**RTCA Special Committee 209**

**Mode S Transponder MOPS Maintenance**

**Working Group #1, Meeting #6**

**Trig Avionics Proposal for a Revised  
Whisper-Shout Requirement and Test Procedure**

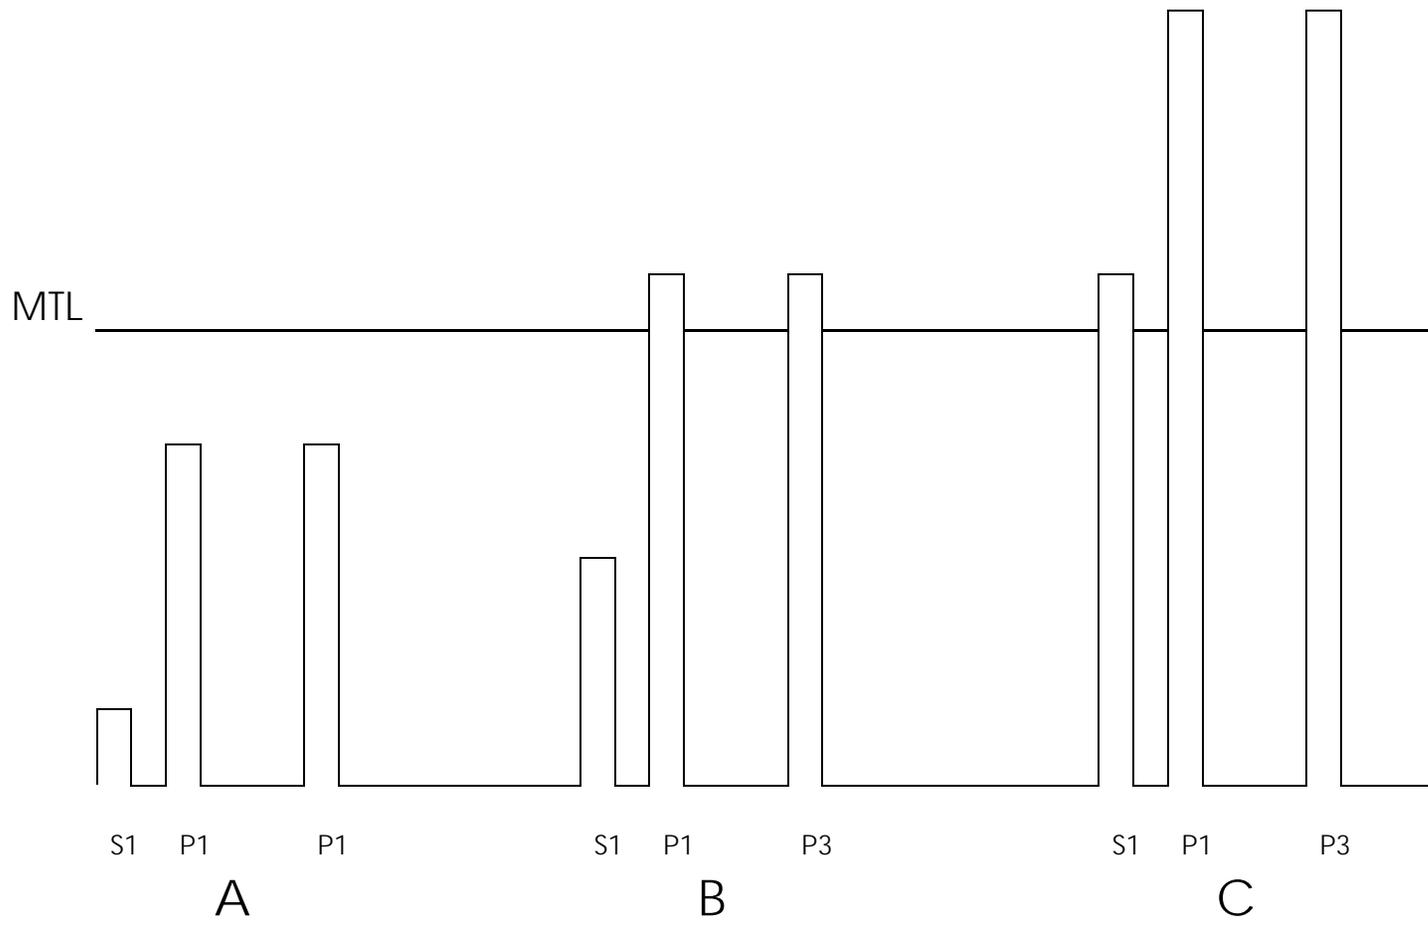
The TCAS requirement is that when S1 and P1/P3 bracket the MTL, the transponder will reply with high probability for all power levels within the non-overlapping portion of the interrogator window. Rephrased as a requirement on the transponder, this would be:

With an S1 pulse 7.5 dB below the P1 pulse, the reply ratio to Mode C interrogations shall be not less than 70% for all levels of P1 between MTL and MTL+6dB.

# Example Whisper Shout operation

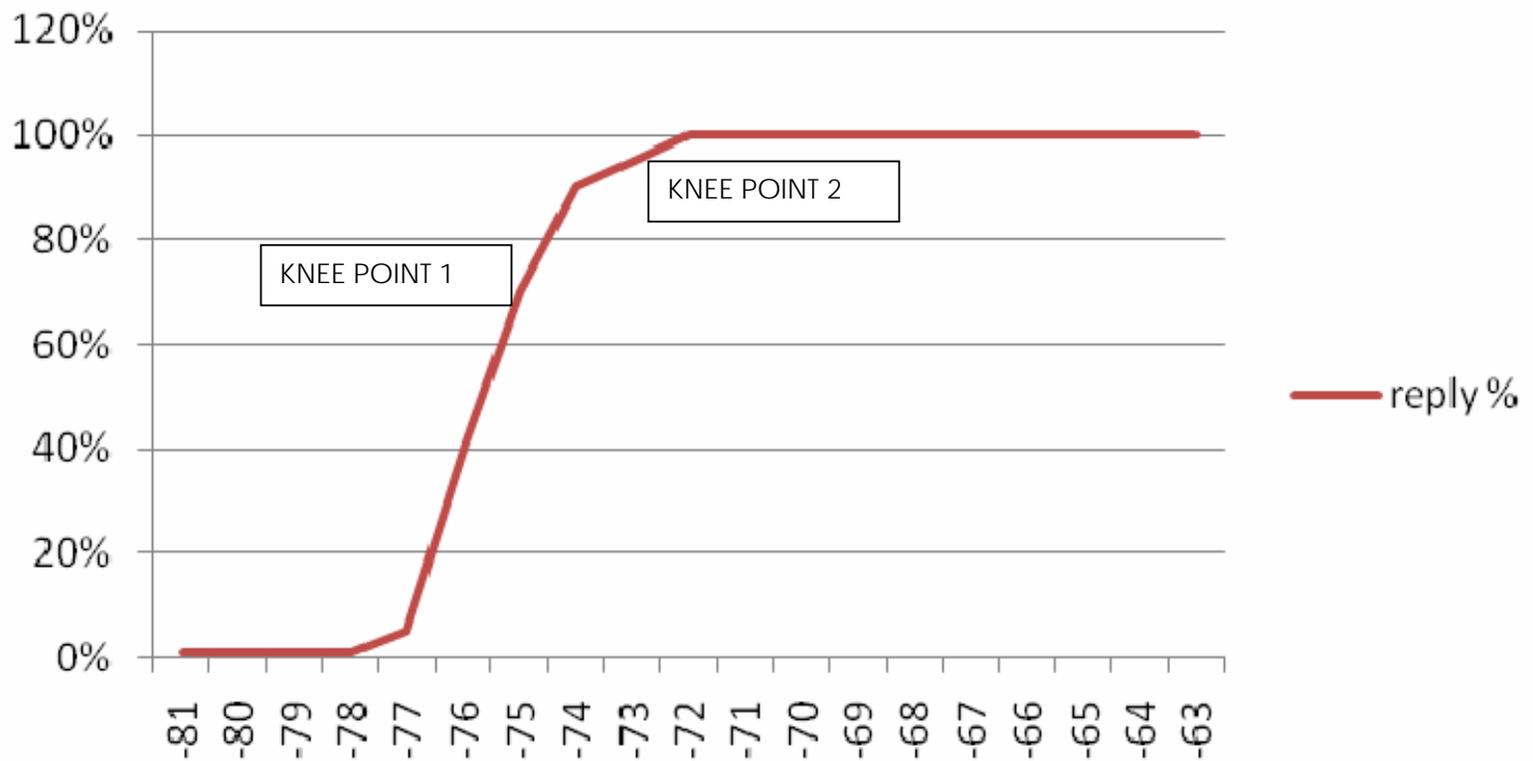
Our analysis shows that the hardest part of this new requirement for many transponders is not the reply ratio when P1/P3 is at MTL and S1 is at MTL-7.5dB. Since the S1 pulse is well below the pulse detector threshold, that is not particularly different to the original MOPS requirement for MTL. (Even the erroneous GTX330 replies to that test point). The harder part is maintaining the reply rate when the interrogation is at the **upper** end of the window. When the P1/P3 pair are at MTL+6dB the S1 pulse is only MTL-1.5dB, and depending on the receiver design quite a few of those pulses will be recognised. That is why the success criteria is set at only 70%, rather than the more usual 90%.

With an S1 pulse 7.5 dB below the P1 pulse, the effective reply ratio of a pair of Mode C interrogations spaced at interrogation levels spaced 6dB apart shall be not less than 60% for all levels of P1 between MTL-3 and MTL+9dB. The effective reply ratio is  $(1 - ((1 - \text{reply ratio}_1) \times (1 - \text{reply ratio}_2)))$ .
